RE: 22-125120-PLN  
Reid Saunders Association  
3985 Lindburg Road SE  
Salem, OR 97302

We wish to express our appreciation for your timely review of the Construction Documents for Reid Saunders Association. Attached is your Plan Review Comments, and following are our proposed responses.

REID SAUNDERS ASSOCIATION  
PROJECT NUMBER: 2022.0003  
STATE OF OREGON 2022 STRUCTURAL SPECIALTY CODE, AMENDMENTS BASED ON 2021 IBC

2 ENLARGED BIKE RACK PLAN  
SCALE: 1"=10'-0"

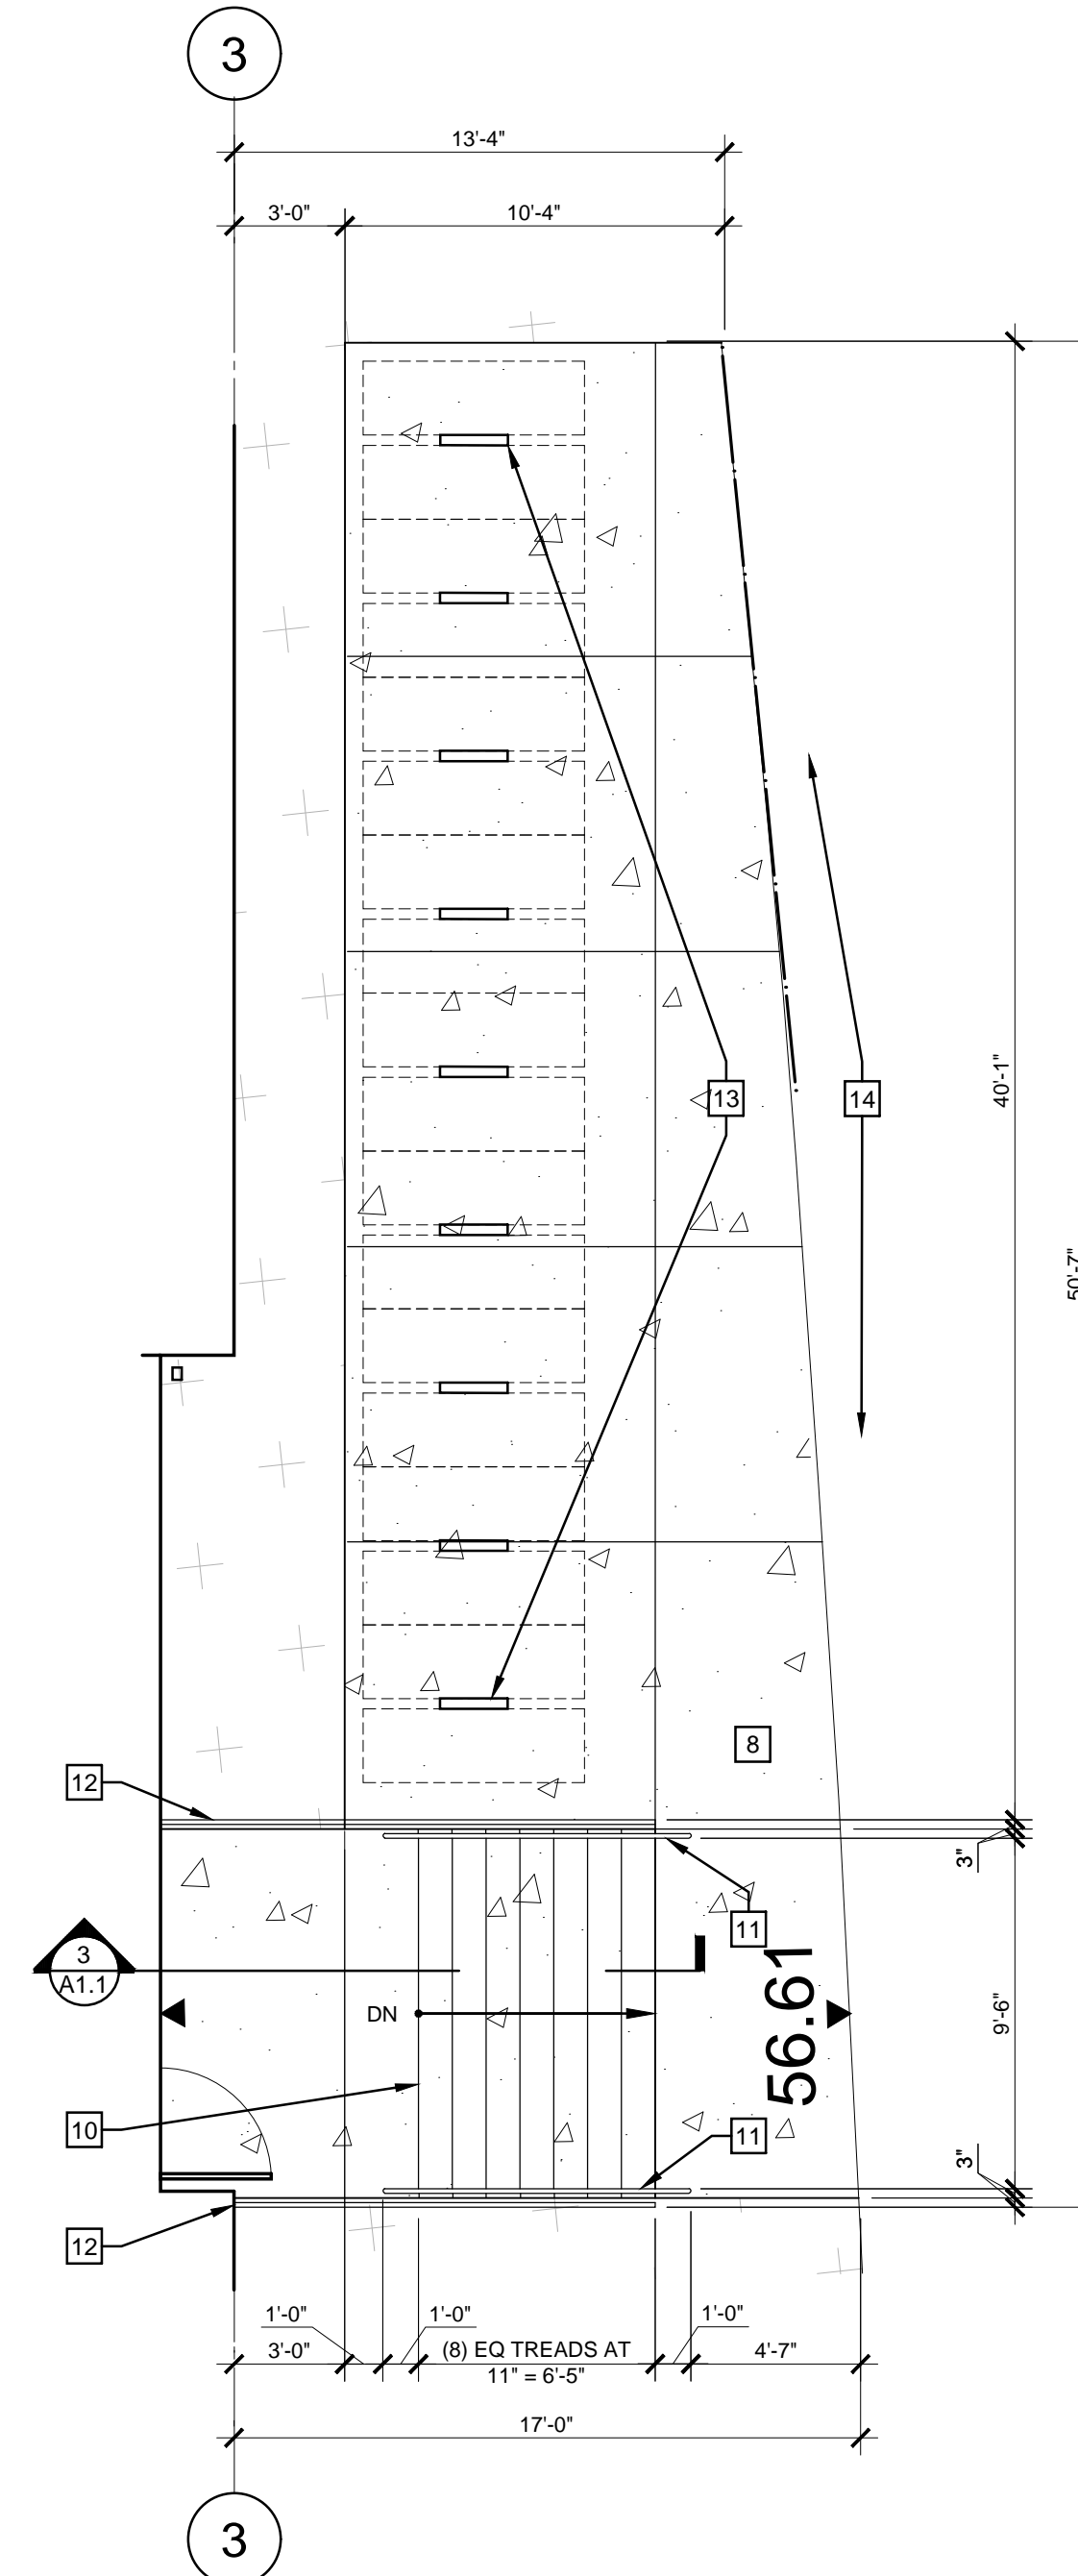
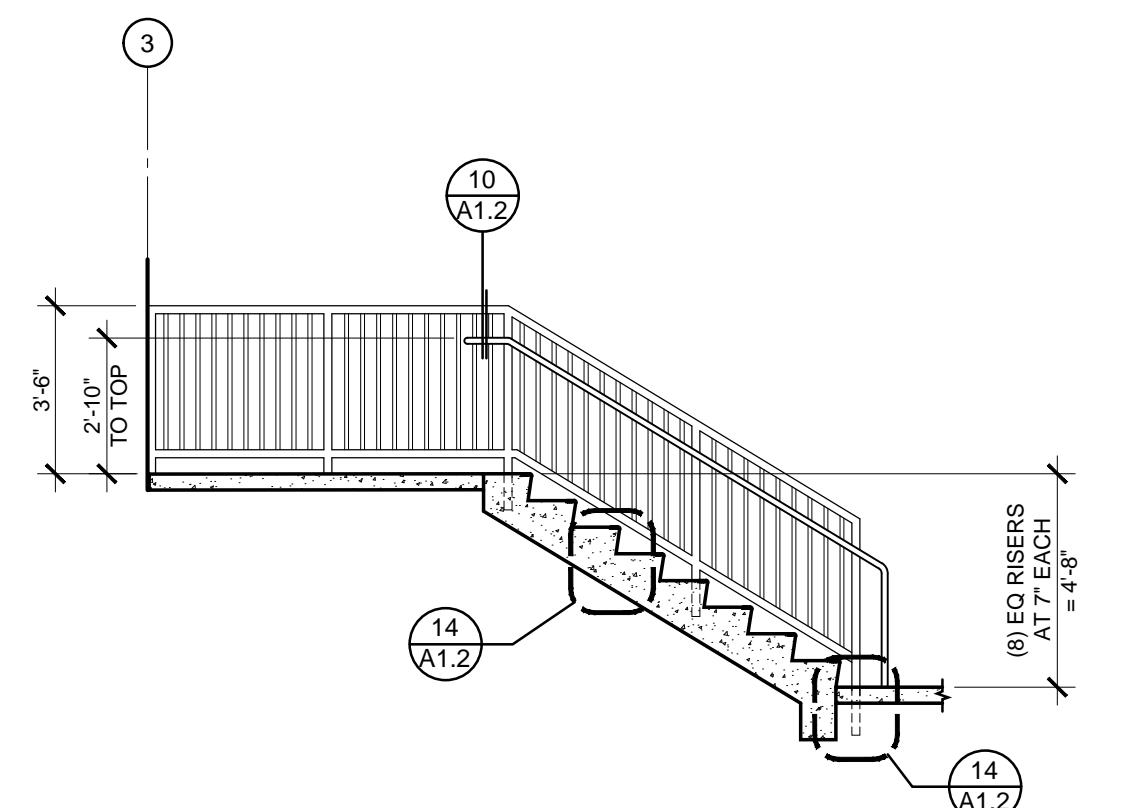
- ii. The bike rack positioning is shown on detail 12/A1.2, attached. The enlarged plan was intended to be diagrammatic, which is why it wasn't dimensioned. The plan been updated to show the racks' actual placement within the clearance zone.
